# Staff Report

Subject: **101 Main Street – Request for Determination of Applicability – No DEP#, Fairhaven CON 023-247**

Subject: **Huttleston Ave, Map 31, Lots 115A & 117C – Notice of Intent – DEP# 023-1308, Fairhaven CON 023-095**

Date: September 27, 2021  
To: Conservation Commission  
From: Whitney McClees, Conservation Agent  
Subject: **4 Fox Run Lane – Notice of Intent – DEP# 023-1363, Fairhaven CON 023-244**

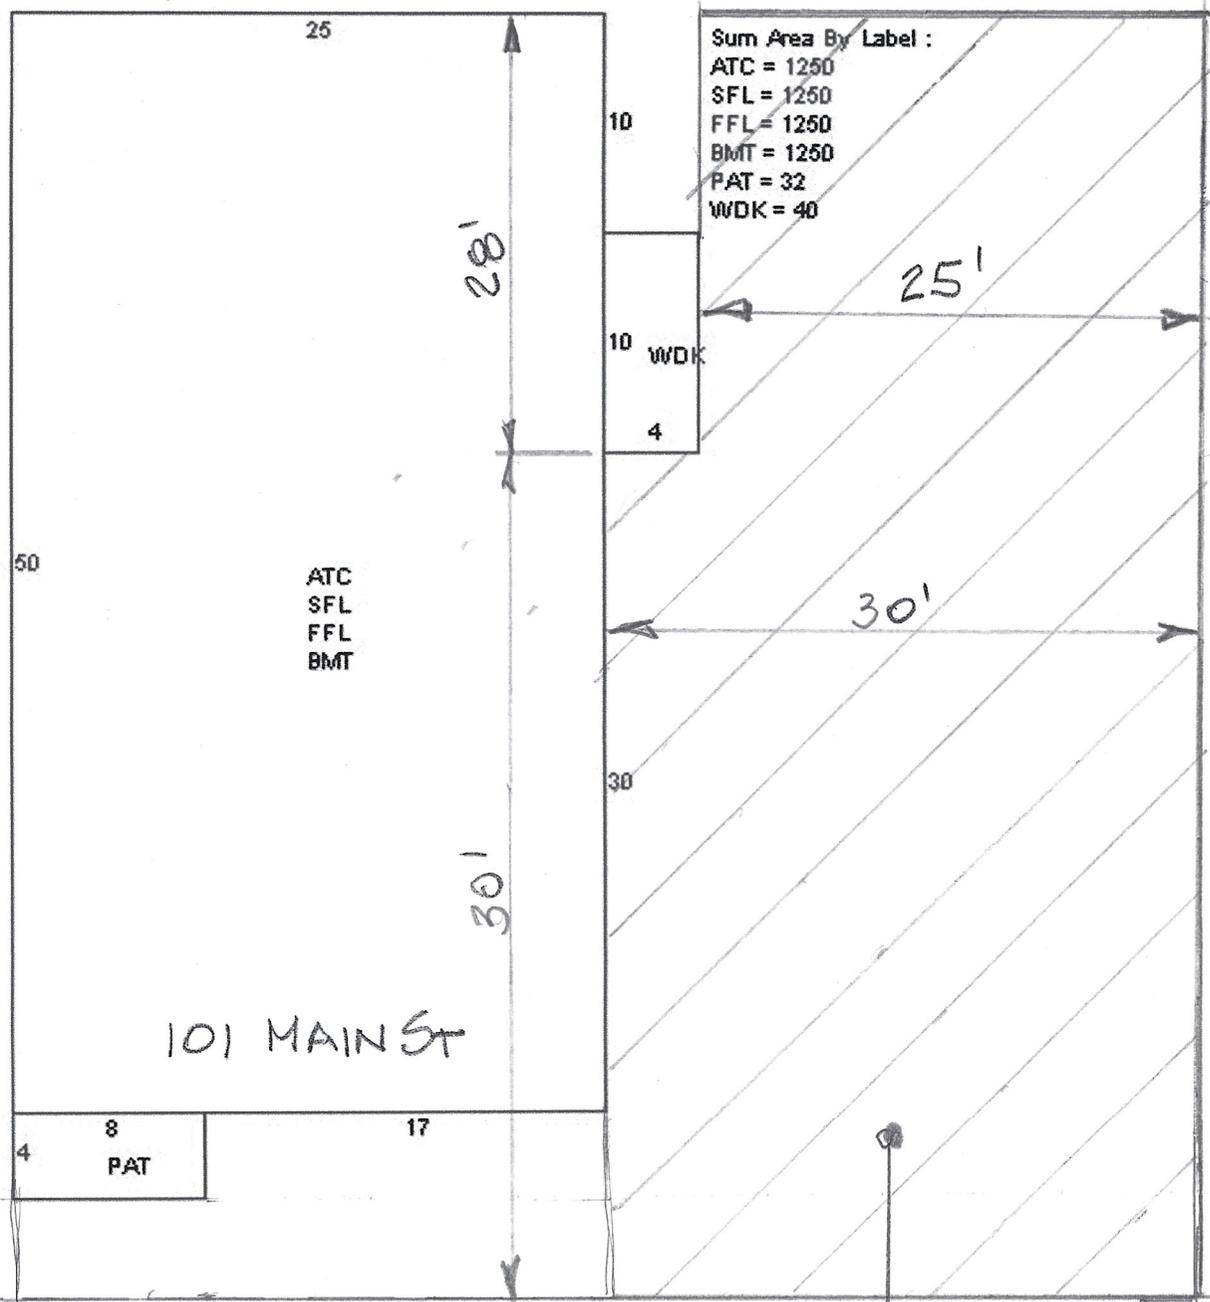
- The entire property falls within the AE flood zone inside the hurricane barrier.
- There are no other resource areas within 100 feet of the property.
- The majority of the property will remain pervious.
- The proposed project does not appear as if it will have a negative impact on storm damage prevention or flood control.

- I recommend closing the public hearing for 101 Main Street, CON 023-247, and issuing a Negative 2 and Negative 6 Determination under the Wetlands Protection Act and Fairhaven Wetlands Bylaw.
